# 534 LAKEVIEW ST. REPLAT

## SUMMARY

<p><b>Owner</b> Michelle Kechriotis</p> <p><b>Applicant</b> Frank A. Raymond, President Accuright Surveys Orlando, Inc.</p> <p><b>Project Planner</b> TeNeika Walker, Planner I</p> <p><b>Updated:</b> August 7, 2014</p>	<p><b>Property Location:</b> 534 Lakeview St. (on the south side of Lakeview St., between Edgewater Dr. and Edwards Ln.; PID: 23-22-29-0000-00-021 ) (±2.25 acres, District 3).</p> <p><b>Applicant's Request:</b> The applicant is requesting a minor plat of the property as a result of a substantial improvement for a new house.</p>	<p><b>Staff's Recommendation:</b> Approval of the request, subject to the conditions in this report.</p>
---	---	--

# PROPOSED PLAT

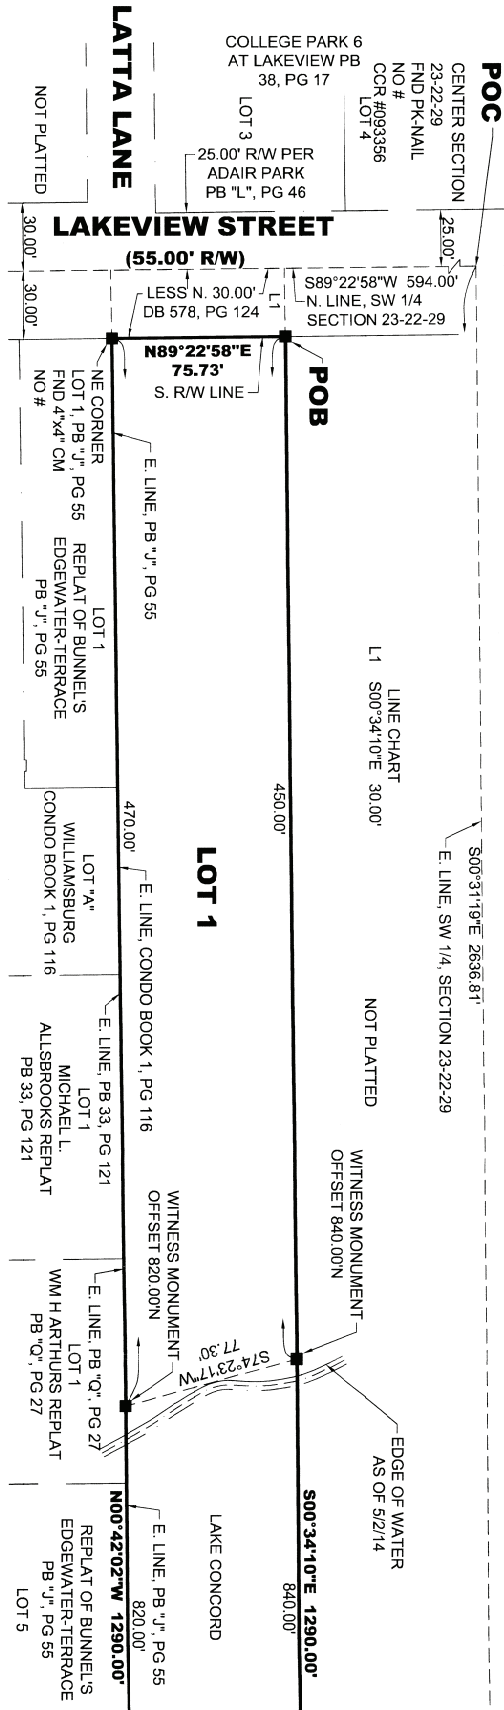
6. Plat Face Changes - There are a number of changes required to the face of the plat. In addition to the changes required on the plat, the following is a list of additional requirements. 1) Changes to the face of the plat. ( A copy has already been returned to the surveyor). 2) Recording Fees (Checks should be made payable Orange County Comptroller.) 3) The plat must be reviewed by Orange County prior to recording. Begin this process by taking a copy of the executed plat to Room 1700 (Orange County Property Appraiser's Office, Attn. Rocco Campanale), 200 S. Orange Avenue, Sun Trust Bank Center. The original completed Statement of Lien from Orange County is required by this office. The Statement of Lien must be received by this office prior to recording the plat.
